# CPED STAFF REPORT

CPC Agenda Item #12  
 July 14, 2014  
 BZZ-6638

**Property Location:** 4250 and 4264 Upton Avenue South  
**Project Name:** Linden Crossing  
**Prepared By:** [Mei-Ling Anderson](#), City Planner, (612) 673-5342  
**Applicant:** Mark Dwyer, Linden Hills Redevelopment, LLC  
**Project Contact:** Mark Dwyer  
**Request:** To construct a four-story, mixed-use building with 20 residential units.  
**Required Applications:**

SECTION LOOKING NORTH

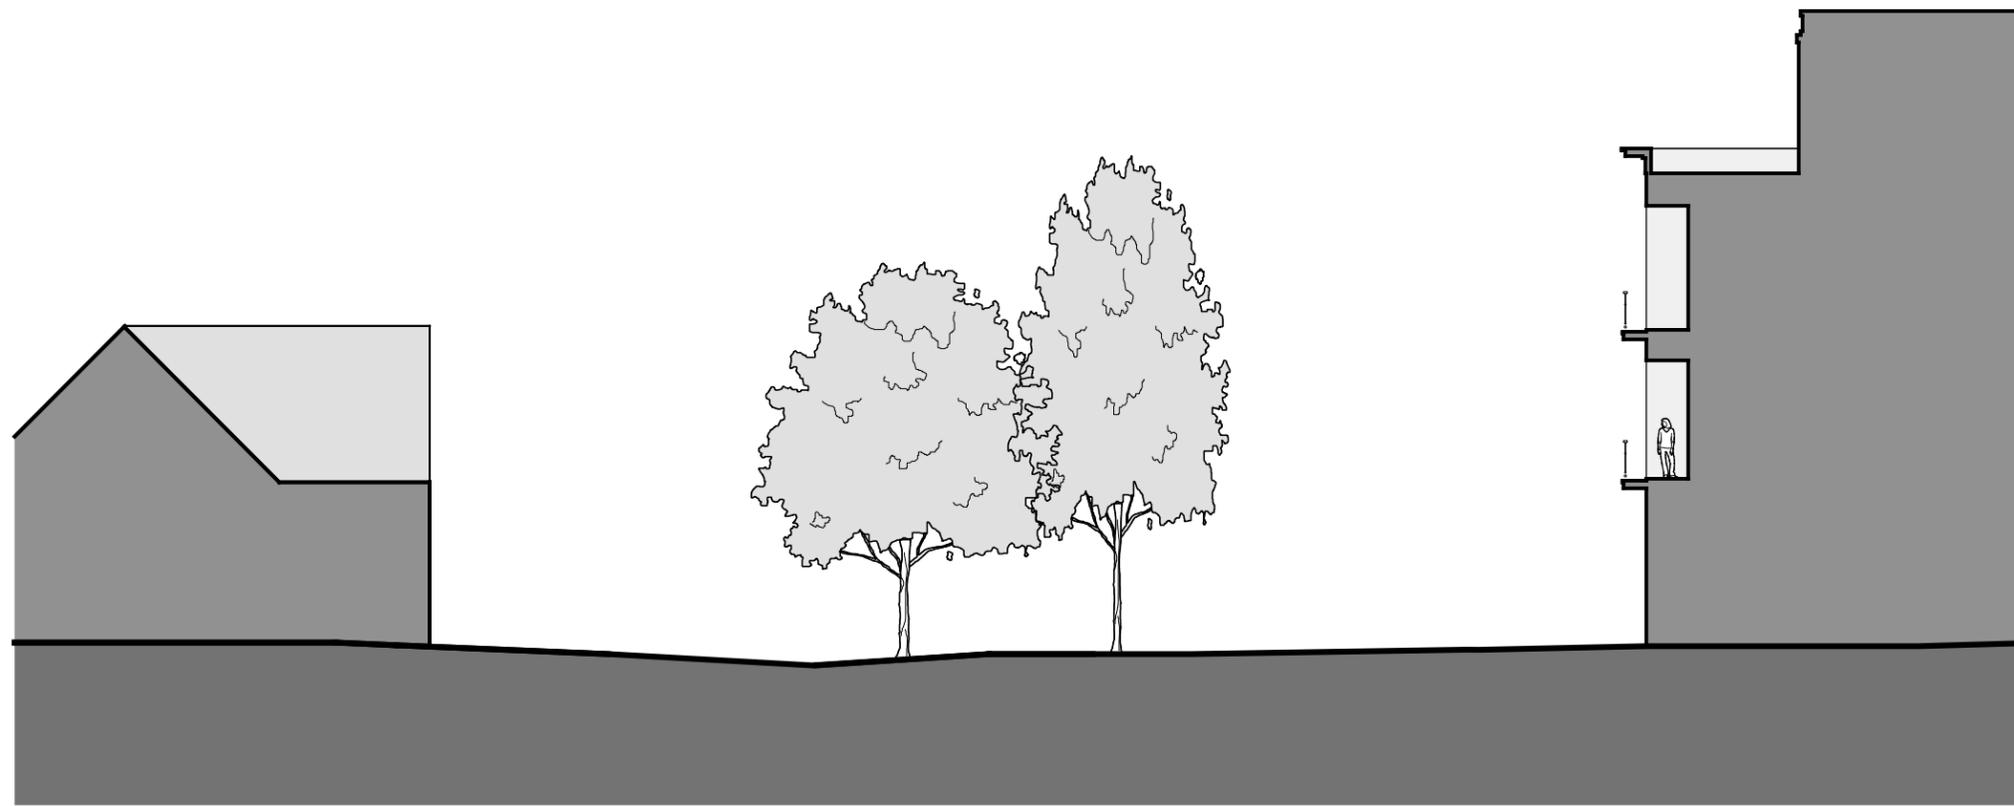
The proposed building would be 56 feet in height as measured from natural grade. However, the building wall adjacent to the public sidewalk would be 42 feet above the adjacent grade, as the fourth story covers the middle 50 percent of the third floor and is stepped back from the edge of the floors below by 12 feet or more on all sides of the property. Increasing the height of the proposed development should not impede access to light and air that the surrounding properties receive.

Shadow Study - Summer Solstice- 9am

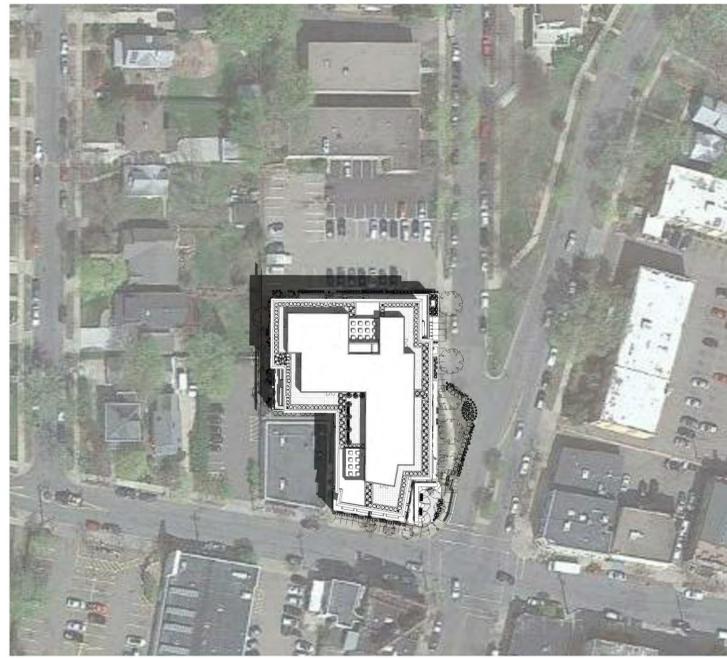
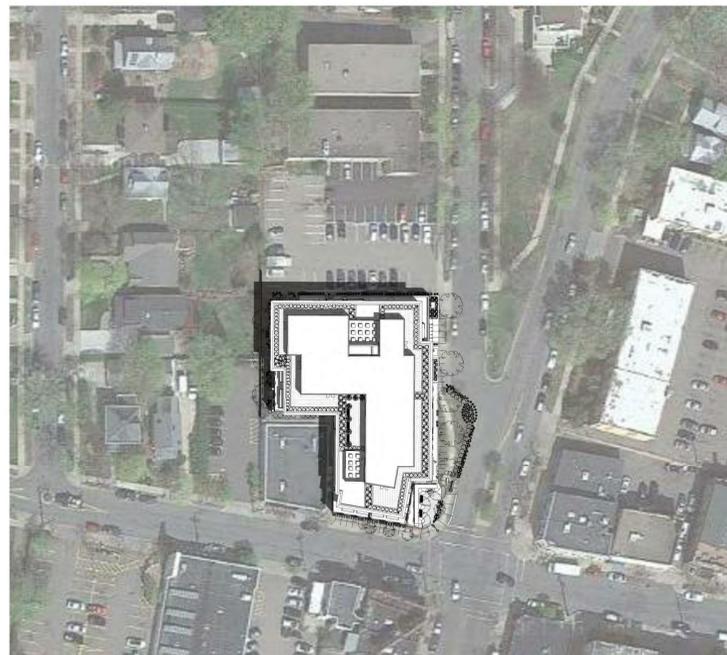
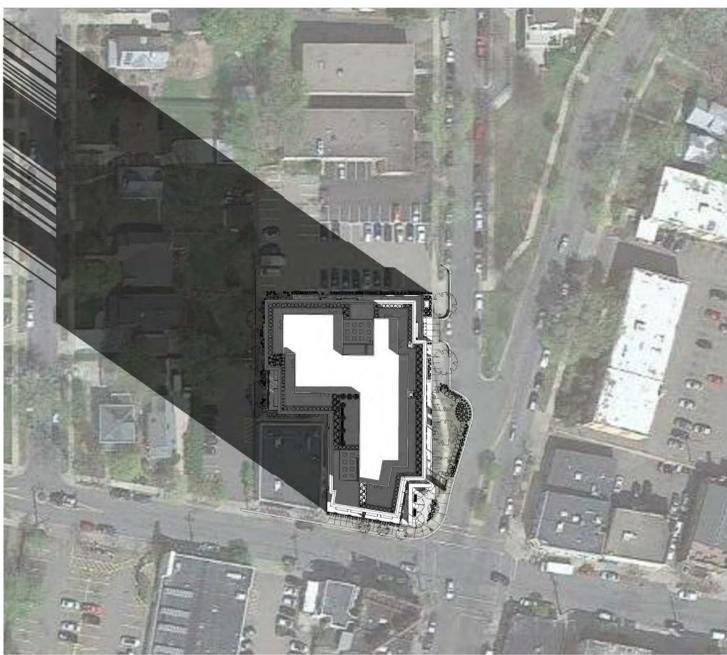
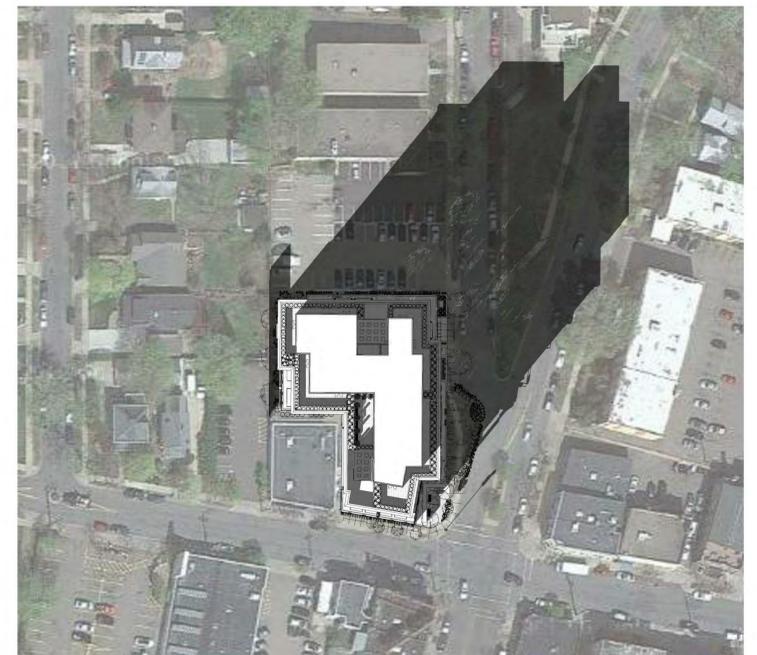
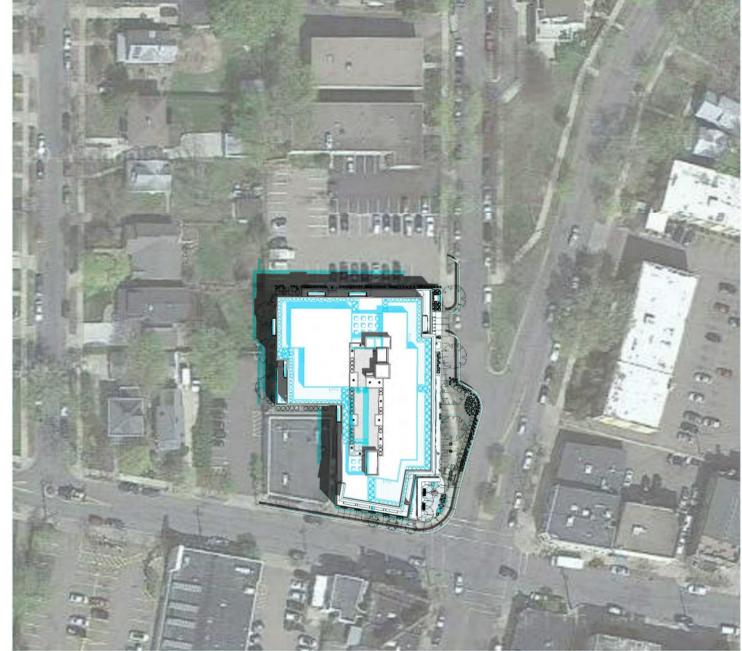
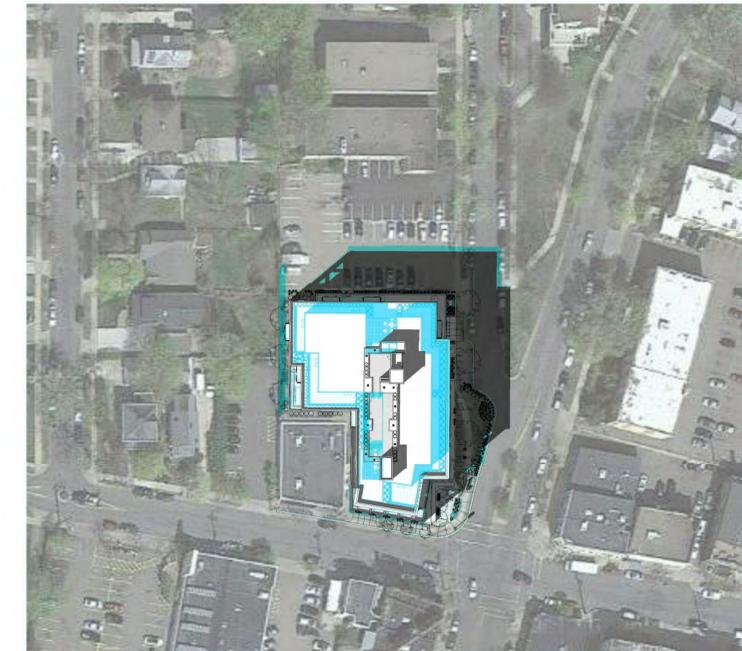
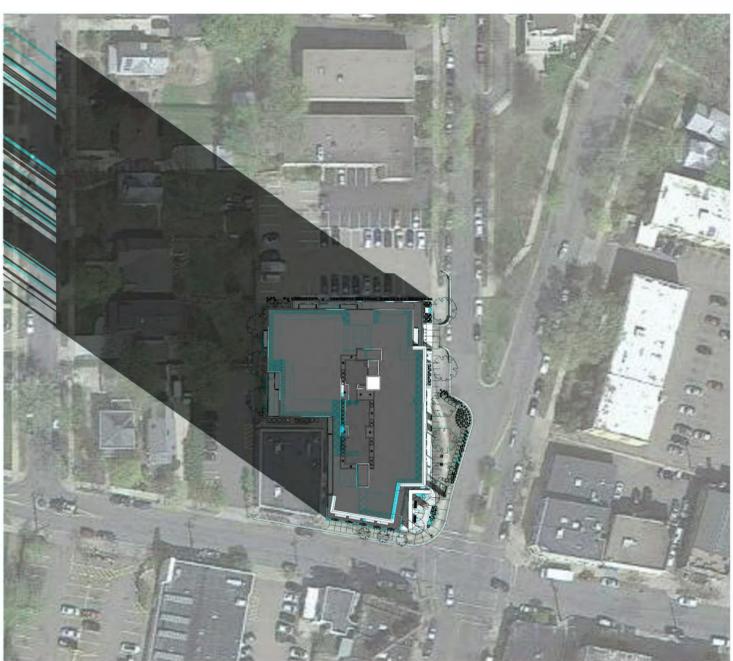
The applicant submitted a shadow study showing the proposed development's impacts at 9 a.m. and 4 p.m. on June 21<sup>st</sup>, on September 23<sup>rd</sup>, and on December 21<sup>st</sup>. The shadow study indicates that there will be minimal shadowing cast on the residential properties located on the north and west sides of the development site during June, September, and December. The study does indicate some shadowing impacts on the residential properties located on the west side of the development in the winter study. The materials also include a comparison of the shadowing effect at same times of day and same times of year for a building that is 42 feet in height within the same building footprint. Due to the fourth level being set back at least 12 feet from the edge of the third floor on all sides of the building, there is little difference in shadowing impacts between the 42-foot proposal and the 56-foot proposal.
